11/14/97	Plan revised to indicate pedestrian and bicycle safe grate GDI's.
DATE	REVISION
STATE OF HAWAII DEPARTMENT OF TRANSPORTATION HIGHWAYS DIVISION	
DRAINAGE PLAN	
VOLCANO RD. DRAINAGE IMPROVEMENTS	
Vicinity of Keau Town	
F.A. Proj. No. STP-011-2(30)	
Scale: 1"=40'	Date: Oct 1997
SHEET No. <i>HI</i> OF 6 SHEETS

DRAINAGE DETAILS
VOLCANO RD. DRAINAGE IMPROVEMENTS
Vicinity of Keaau Town
F.A. Proj. No. STP-011-2(30)
Scale: 3/4" = 1'-0"
Date: Oct 1997

STATE OF HAWAII DEPARTMENT OF TRANSPORTATION HIGHWAYS DIVISION
DRAINAGE DETAILS
VOLCANO RD. DRAINAGE IMPROVEMENTS Vicinity of Keaau Town F.A. Proj. No. STP-011-2(30)
Scale: 3/4" = 1'-0" Date: Oct 1997
SHEET No. H4 OF 6 SHEETS

DETAILS OF TYPE 61616P DRYWELL AT # STA. 1066+90 LT.

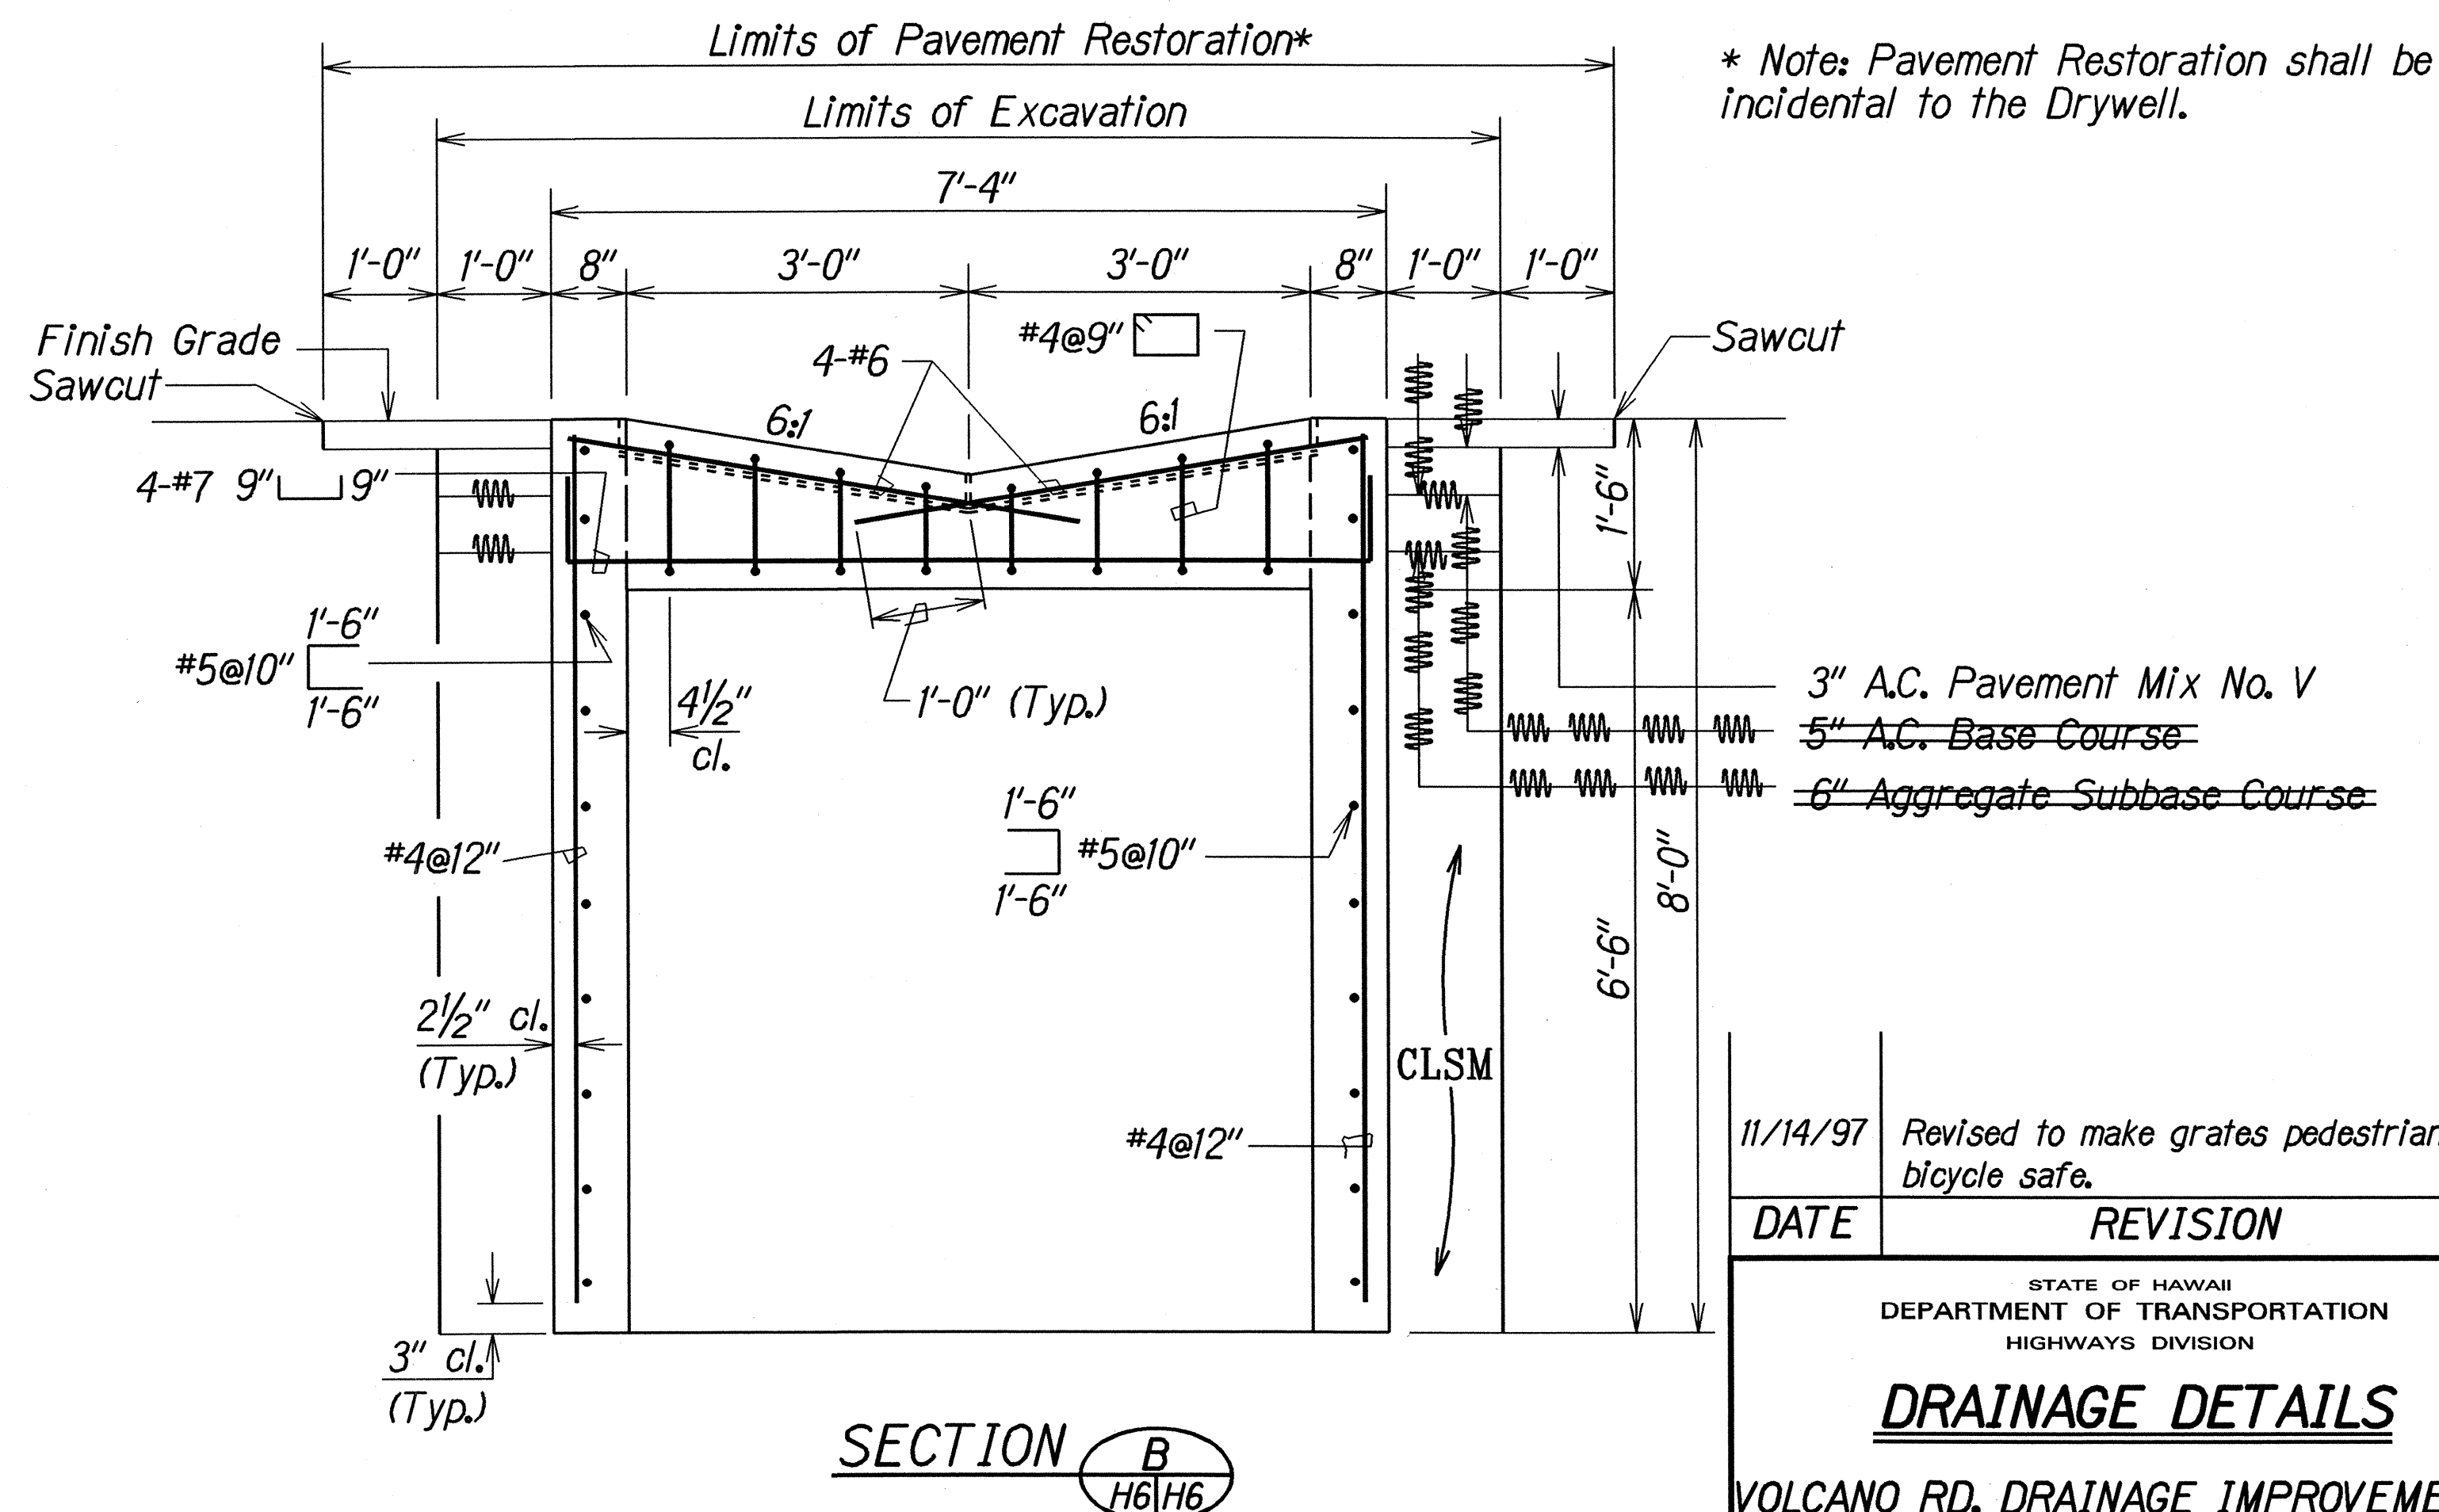
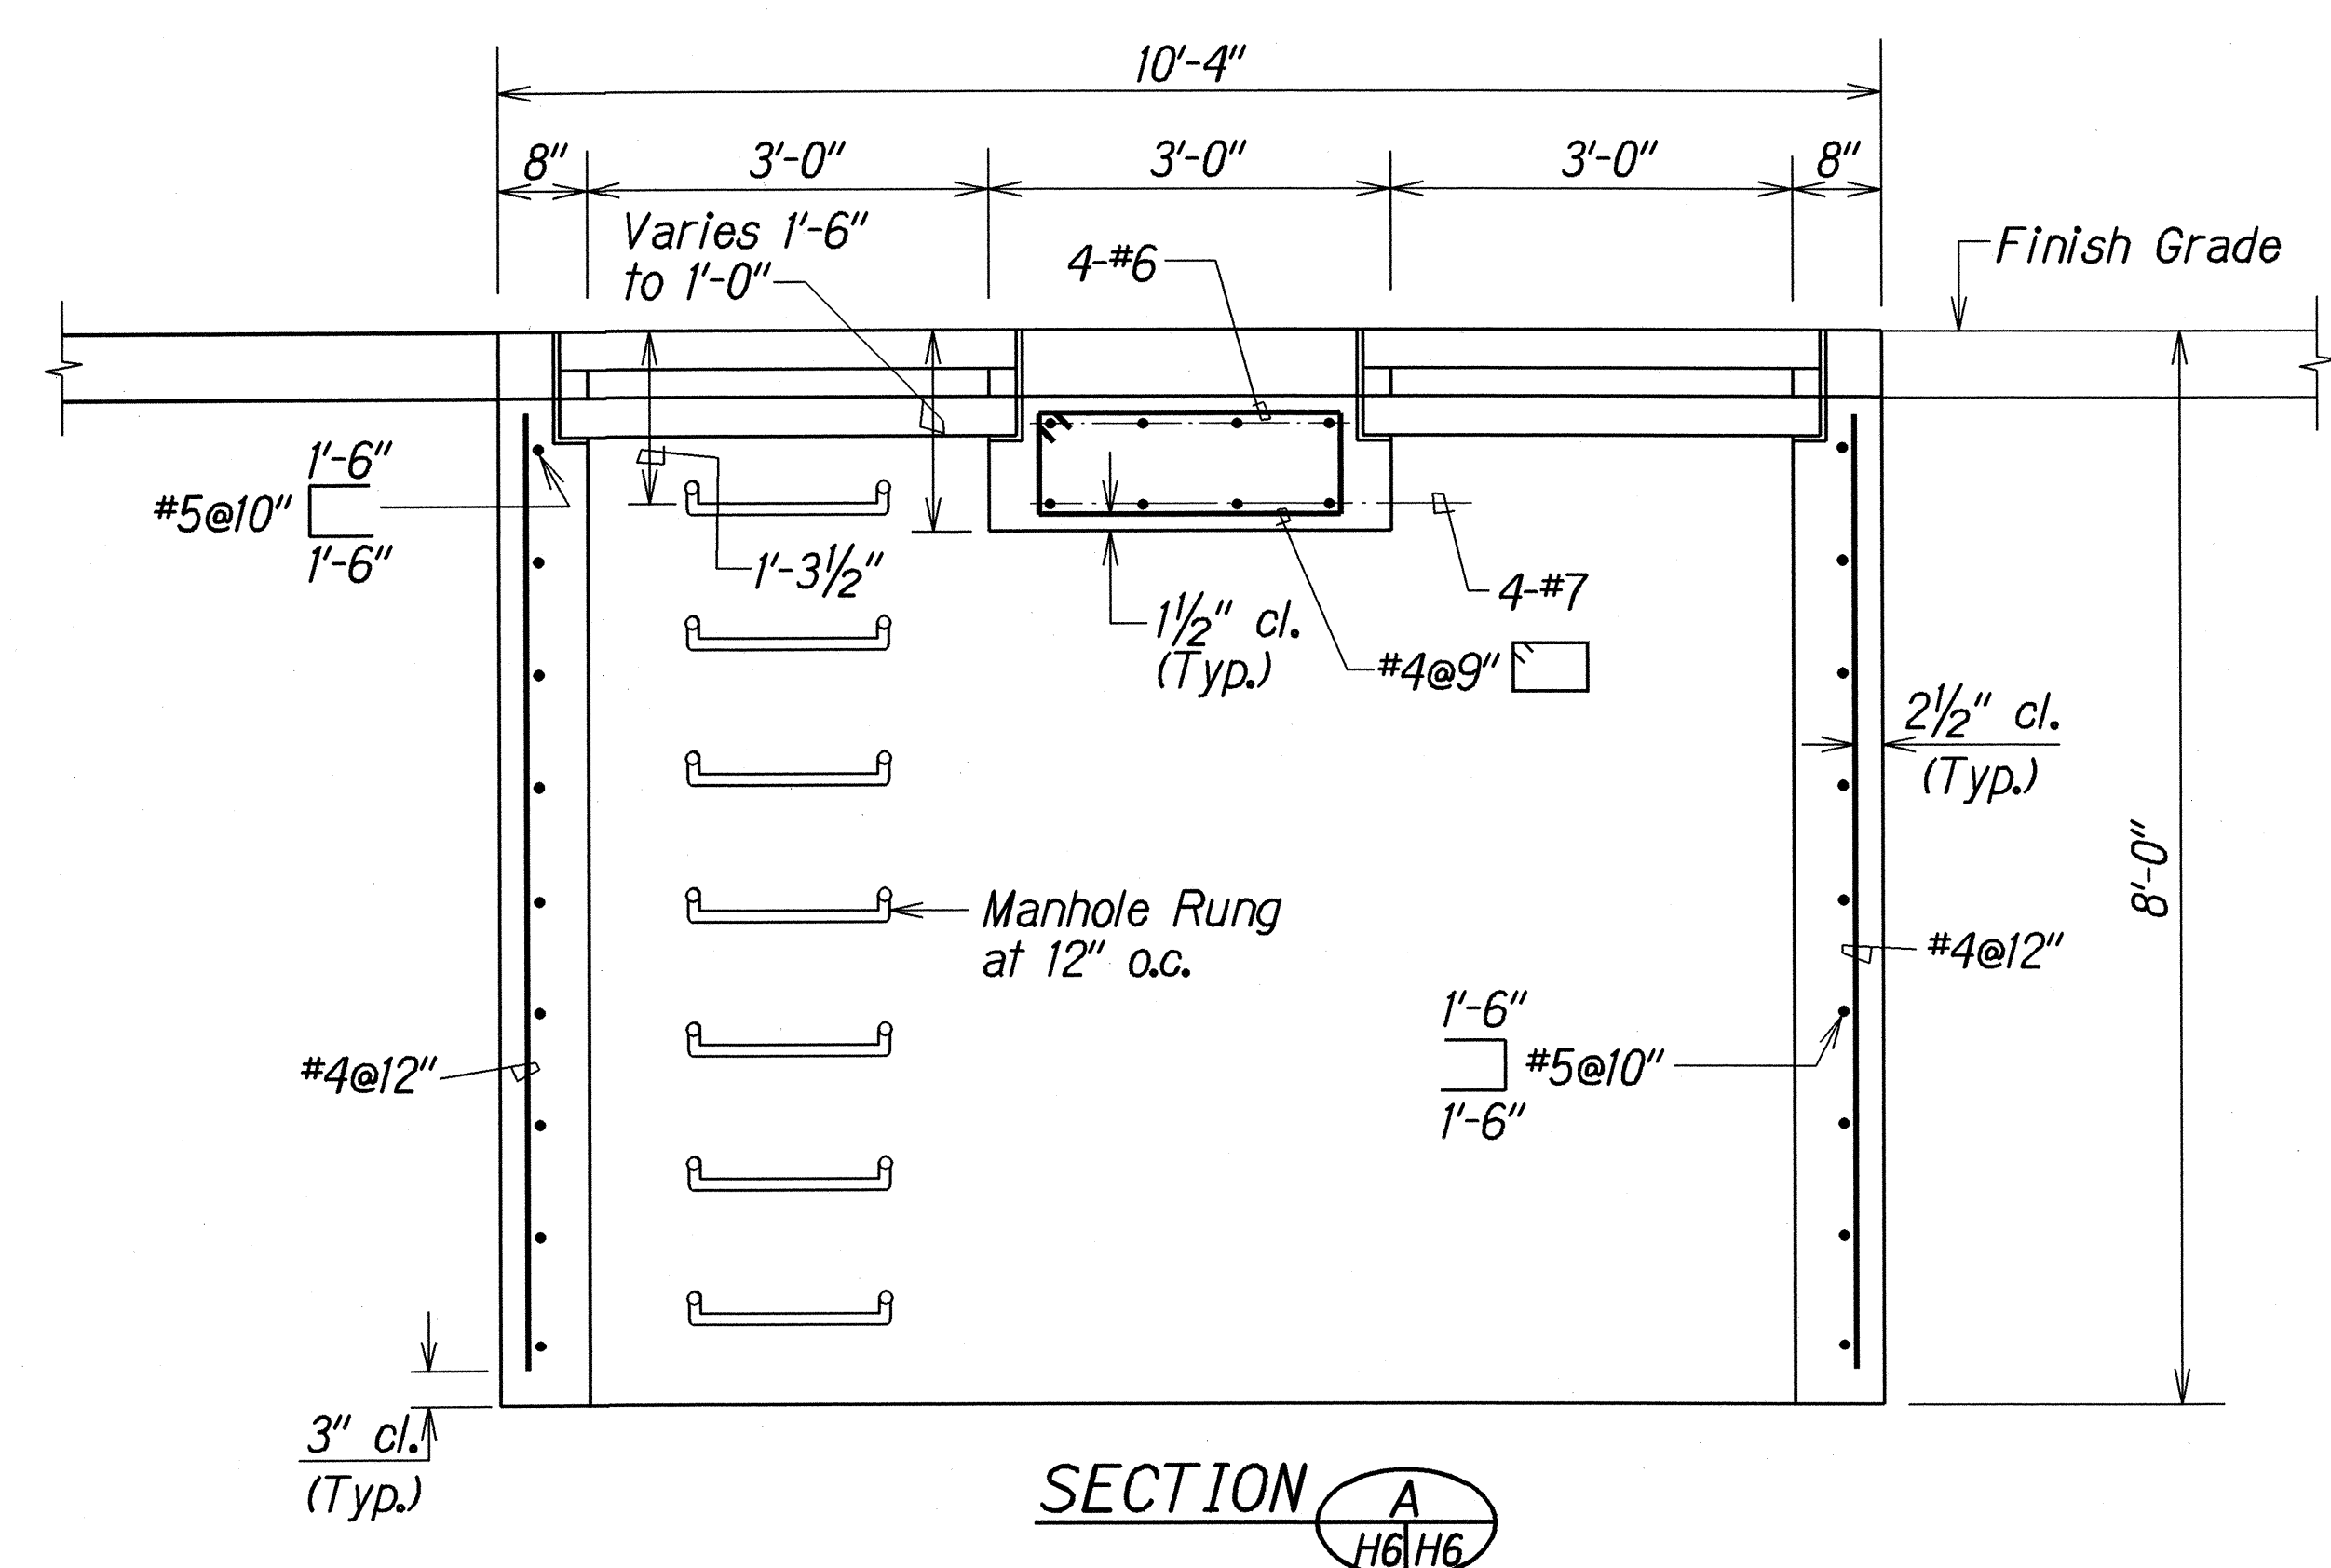
11/14/97	Revised to make grates pedestrian and bicycle safe.
DATE	REVISION
STATE OF HAWAII DEPARTMENT OF TRANSPORTATION HIGHWAYS DIVISION	
DRAINAGE DETAILS	
VOLCANO RD. DRAINAGE IMPROVEMENTS	
Vicinity of Keaau Town	
F.A. Proj. No. STP-011-2(30)	
Scale: 3/4"=1'-0"	Date: Oct 1997
SHEET No. H6 OF 6 SHEETS
